City of Canby

REVISED STAFF REPORT

FILE #: SUB 17-05 – SEVEN ACRES SUBDIVISION

Revised for the October 23, 2017 Planning Commission Meeting

SUBTITLE	N. MAPLE ST – OPTION 2	JOB NO.:
TITLE	7 ACRE SITE N. MAPLE ST. CANBY, OR	DWG. NO.:
		SCALE:
		SHEET:

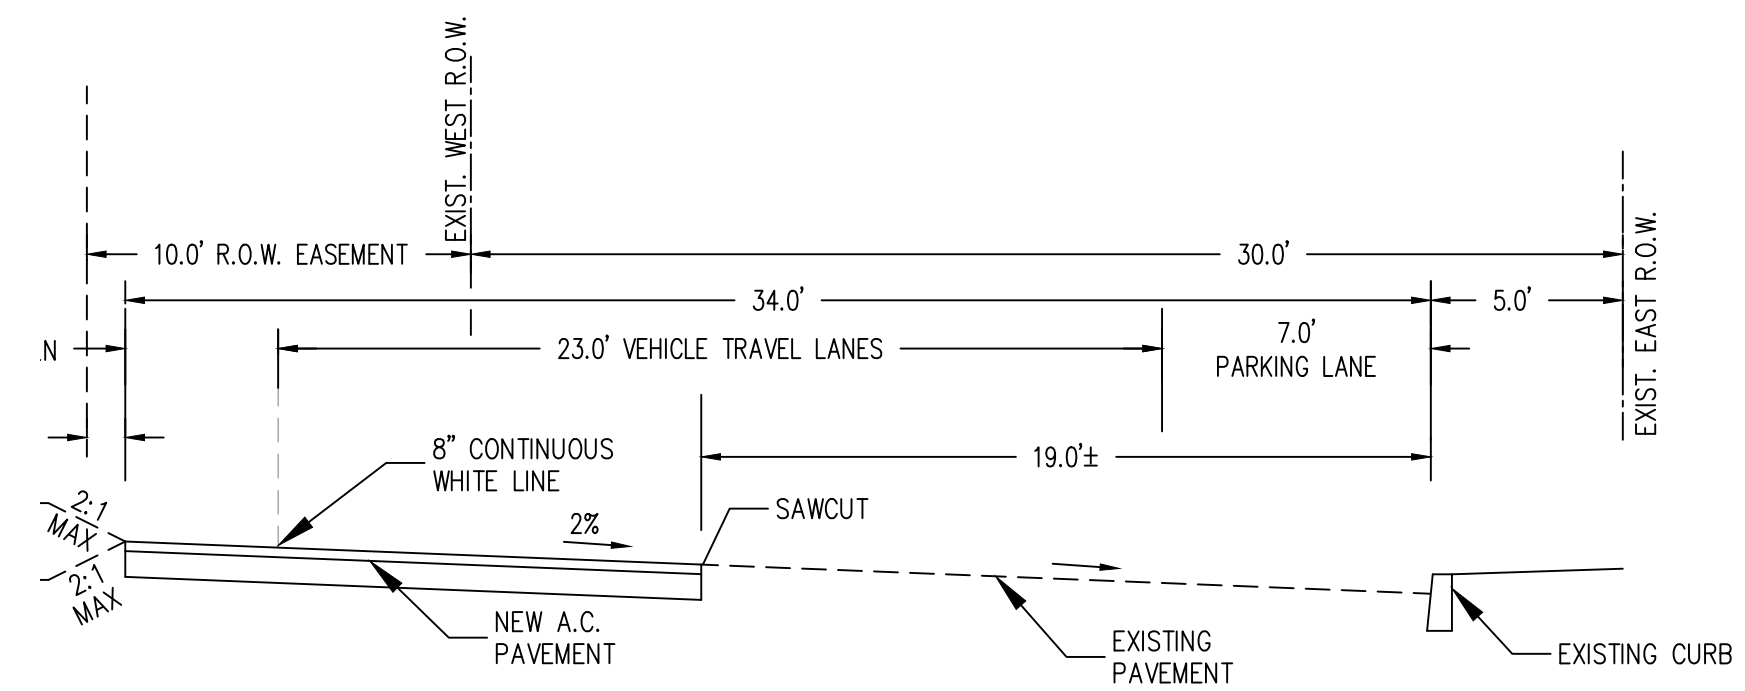
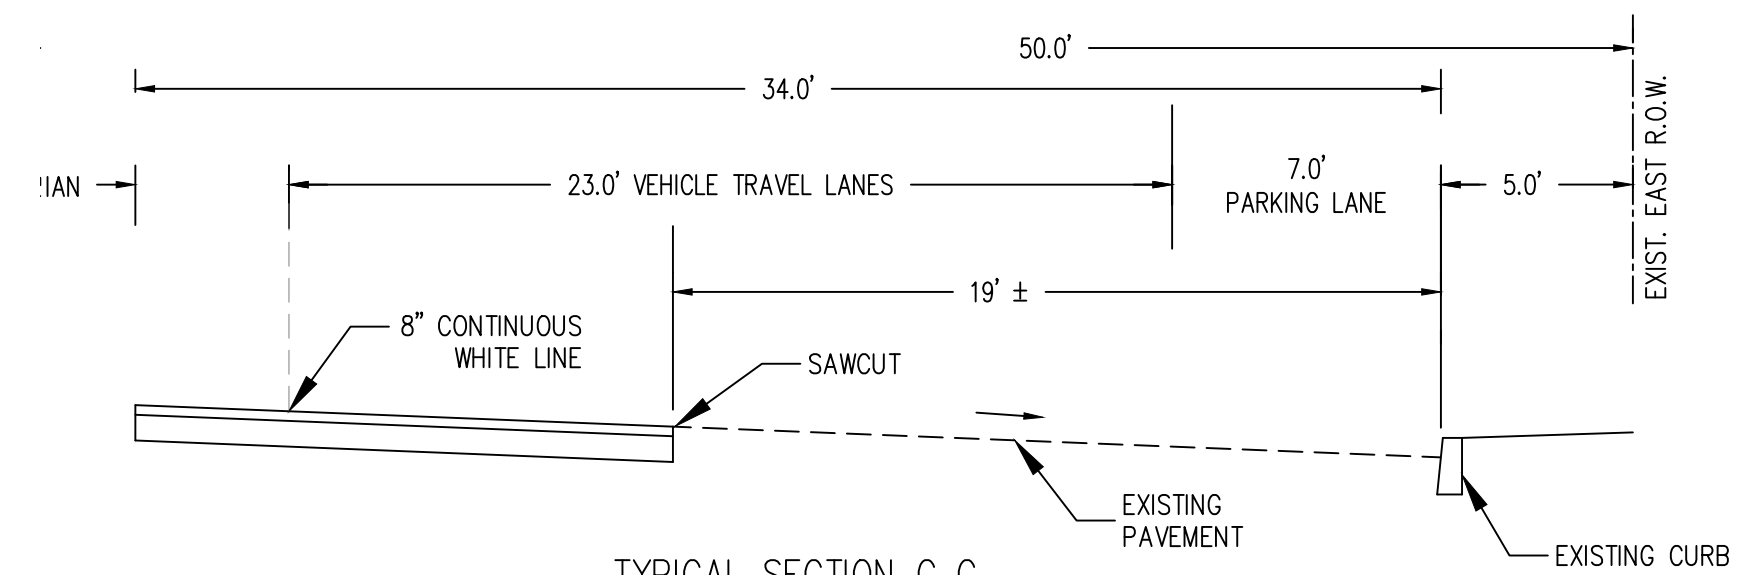
- 2. If the existing Right of Way is definitively found to be 50' wide prior to applicant's construction plan preparation, the applicant will widen N. Maple Street from approximately NE 23rd Avenue (at the southern termination of the existing sidewalk) north to the north property boundary of Tax Lot 31E 28A 00900, to 34' at the City's request as shown on Exhibit 13 – Maple Street ROW Option 2

4. If the existing Right of Way is definitively found to be 50' wide prior to applicant's construction plan preparation, the applicant will widen N. Maple Street from approximately NE 23rd Avenue (at the southern termination of the existing sidewalk) north to the north property boundary of Tax Lot 31E 28A 00900, to 34' at the City's request as shown on Exhibit 13 – Maple Street ROW Option 2

b. If an agreement is reached with the owners of Tax Lot 31E21 00300, up to and prior to approval of the final construction plans for N Maple Street, the applicant will widen N Maple Street to 34' along the frontage of Tax Lot 31E21 00300 per Exhibit 13 – Maple Street ROW Option 2 – Cross Section A-A.

SUBTITLE	N. MAPLE ST - OPTION 1	JOB NO.:
TITLE	7 ACRE SITE N. MAPLE ST. CANBY, OR	DWG. NO.:
		SCALE:
		SHEET:

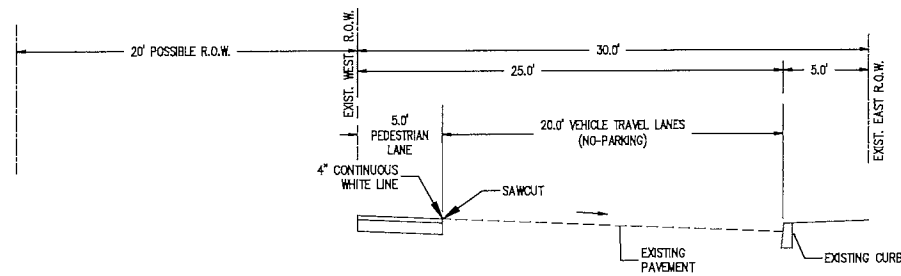
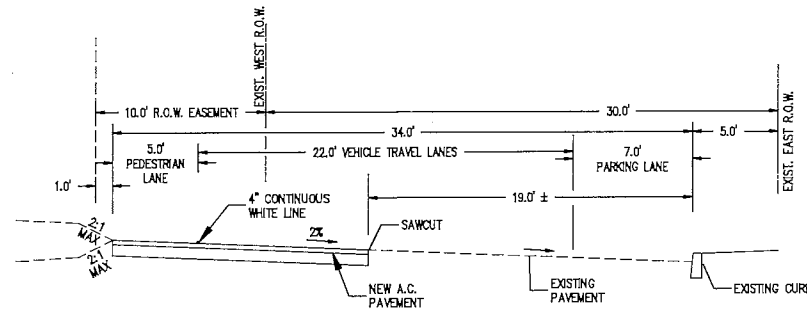
1. Widen this segment to 25' to allow 7' of existing parking to remain on the east side of N. Maple Street and provide for a 13' 4" travel lane and a 4' 8" pedestrian and emergency vehicle lane. In this option, fire sprinklers would be required on all lots in the proposed subdivision. See Exhibit 12 – Maple St. Option 1 Section A-A

2. Widen this segment to 25' to allow 7' of existing parking to remain on the east side of N. Maple Street and provide for an 18' travel lane and shared pedestrian lane. In this option, fire sprinklers would be required on all lots in the proposed subdivision. See Exhibit 12 – Maple St. Option 1 Section B-B

- a. Option 1A – Widen this segment to 25’ to allow 7’ of existing parking to remain on the east side of N. Maple Street and provide for a 13’ 4” travel lane and a 4’ 8” pedestrian and emergency vehicle lane. In this option, fire sprinklers would be required on all lots in the proposed subdivision.

- b. Option 1B - Widen this segment to 25’ to allow 7’ of existing parking to remain on the east side of N. Maple Street and provide for an 18’ travel lane and shared pedestrian lane. In this option, fire sprinklers would be required on all lots in the proposed subdivision.
